Access Compliance Report

Public Rights-of-Way

(Curb Ramps)

Intersection ID: 46754	Main Street: SUPERIOR_ST	Cross Street: TAHOE_DR	Location: W
ADA ID: CBBD252DF14D	Ramp Type: BlendTrans1	Initial Pass/Fail: Fail	Overall Compliance: No
Severity Score: 21.25			
Codes/Mitigation Info/Possible Solution		Field Measurements/Component Compliance

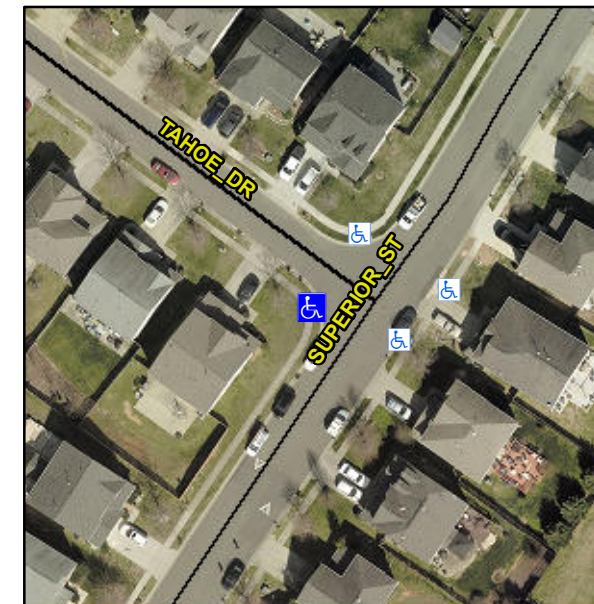
Not Found, R304.5.1, R304.5.3

Compliance	Description	Data	Compliance	Description	Data
N/A	Ramp Length (in)	46.0	Yes	BlendTrans Slope (%)	4.6
No	Ramp Width (in)	43.0	No	BlendTrans XSlope (%)	5.4
N/A	Flare Type LT	N/A	N/A	Flare Type RT	N/A
N/A	Flare Slope LT (%)	N/A	N/A	Flare Slope RT (%)	N/A
N/A	Flare Traversable LT?	N/A	N/A	Flare Traversable RT?	N/A
N/A	Landing Length (in)	N/A	N/A	DWS Provided?	N/A
N/A	Landing Width (in)	N/A	N/A	DWS Contrast?	N/A
N/A	Landing Slope (%)	N/A	N/A	DWS Length (in)	N/A
N/A	Landing X Slope (%)	N/A	N/A	DWS Full Width?	N/A
N/A	Landing Curb? (Y/N)	N/A	N/A	DWS Offset (in)	N/A
N/A	Shared Landing?	N/A			
N/A	Gutter Ponding?	N/A	N/A	Gutter Slope (%)	N/A
N/A	Gutter Lip Ht (in)	N/A	N/A	Gutter X Slope (%)	N/A
N/A	Painted X Walk1?	No	N/A	Painted X Walk2?	No
	X Walk 1 Direction	To SE		X Walk 2 Direction	To NE
	X Walk 1 Width (in)	N/A		X Walk 2 Width (in)	N/A
	X Walk 1 Slope (%)	2.9		X Walk 2 Slope (%)	4.8
	X Walk 1 X Slope (%)	4.6		X Walk 2 X Slope (%)	1.0

N/A	Ramp inside XWalk1?	N/A	N/A	Ramp inside XWalk2?	N/A
	Road Slope (%)	3.1		Clear Space?	N/A
	Road X Slope (%)	5.2	N/A	Clear Space to XWalk (in)	N/A
N/A	Any Obstructions?	N/A	N/A	Storm Grate/Utility Hazard?	N/A
	Obstruction Type			Storm Grate/Utility Type	
		N/A			N/A
			Yes	Surface Condition? (G/P)	Good
			No	Curb Slope (%)	9.9

Remove & Replace Curb Ramp With Two New Directional Ramps or Equivalent.
